Monroe A. Miller, Jr.
19 Big Spruce Lane
Waynesville, NC 28786
September 4, 2010
(Rev. a, 9/9/2010)

Supplement - What is known about the FLS HCC Design at this point in time.

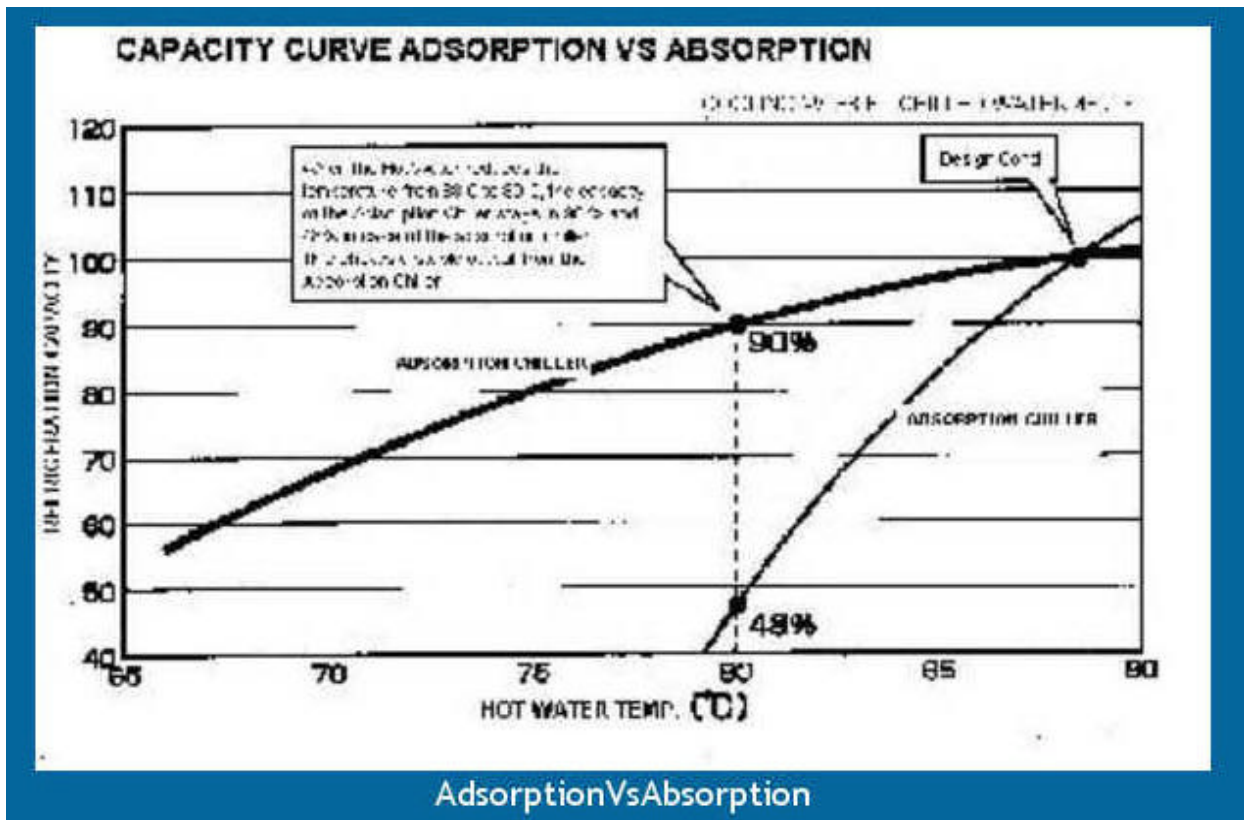
we both said almost simultaneously, the efficiency of an absorption chiller at that temperature will be near zero (0%). See the graph below [re: greenchiller.biz]

The resolution on the graph is as best as I can get, but the top curve is for an Adsorptive chiller (90% at 80° C), and the one that drops off fast (48% at 80°C) is for an Absorptive chiller, the type specified by Michael Nicklas. At 68°C, towards the left end of the curve, it is left to your imagination what the efficiency will be.

Based on this graph, Mr. Freudenberger will have to tell Steve Hunter and me why this graph is wrong, or he will have to reconsider the input temperature to the chiller.
